CNL-16-152

Browns Ferry Nuclear Plant, Units 1, 2, and 3
Renewed Facility Operating License Nos. DPR-33, DPR-52, and DPR-68
NRC Docket Nos. 50-259, 50-260, and 50-296

Subject: **Proposed Technical Specifications (TS) Change TS-505 - Request for License Amendments - Extended Power Uprate (EPU) - Supplement 32, Revised Responses to Requests for Additional Information**

Enclosure: Revised Responses to NRC Requests for Additional Information
SCVB-RAIs 1 (Revision 2), 16 (Revision 1), 24 (Revision 1), 25 (Revision 1),
and 26 (Revision 1)

Figure SCVB-RAI 16-1: CLTP/EPU LOCA DW TEMP Starting at 150°F

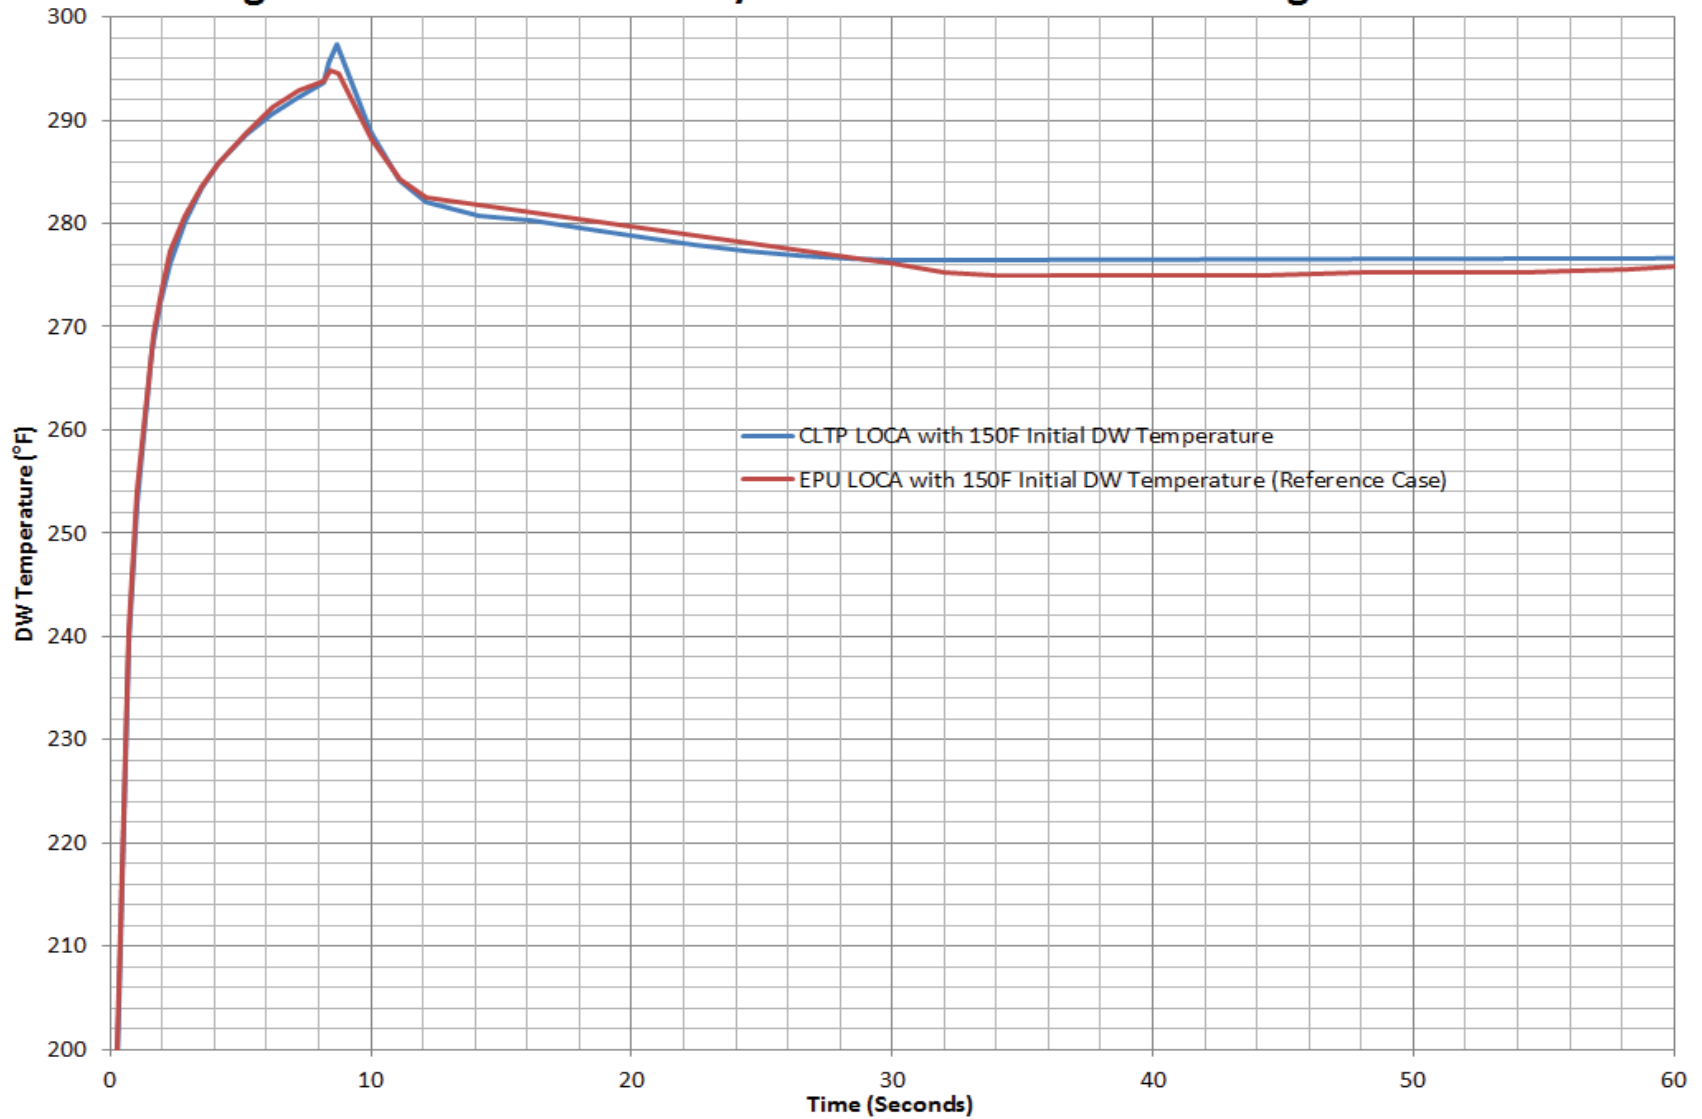
Table 2.6-1 of PUSAR shows peak drywell temperature of 297°F for Units 2 and 3, and 295.2 °F for Unit 1 in the current licensing basis analysis. Table 2.6-1 shows 336.9°F EPU long-term drywell gas temperature for the SSLB. In the current response to Generic Letter (GL) 96-06, the boiling time in the drywell cooling coils of 61 seconds should be based on the short-term drywell gas temperatures.

In the current response to GL 96-06, what are the drywell gas and the RBCCW temperatures used in the analysis to determine the boiling time of 61 seconds in the drywell cooling coils? State the basis for these temperatures and confirm that the both are limiting for the boiling time of 61 seconds in the RBCCW piping and the drywell cooler cooling coils. Provide the same temperature under the EPU conditions with justification that these are most limiting for the boiling time determination in the drywell cooling coils.

- 3) Figure SCVB-RAI 16-1 shows the drywell temperature profiles for a DBA LOCA with an initial drywell temperature of 150°F for both CLTP and EPU conditions. In comparing the drywell temperature profiles, the discussion is separated into the following three time periods:

- The largest difference in temperatures are seen in the first two seconds following a LOCA. The extent of the temperature difference ranges from approximately 6°F at 0.02 seconds to approximately 1°F at two seconds. When coupled with the small time duration, this difference is expected to have little effect on the drywell cooling time to boiling.

- From two seconds to eight seconds, the temperature difference continues to decrease until EPU conditions are bounded by the temperature profile in the CLTP calculation. The small temperature difference, combined with the small time duration is expected to have insignificant effect on the time to boiling.

- For the remainder of the time, the temperature profile associated with EPU conditions is either bounded by, or very close to, the temperature profile from the CLTP calculation.

For Units 2 and 3, both the current licensing basis and the proposed EPU basis for the time to boil are based on the drywell temperature response profile for the DBA-LOCA. Based on the minor differences in the drywell temperature profiles and the margin between the RBCCW pump start (40-43 seconds) and calculated time to boil (61 seconds), it is concluded that voiding will not occur under EPU conditions prior to the restart of the RBCCW pump.
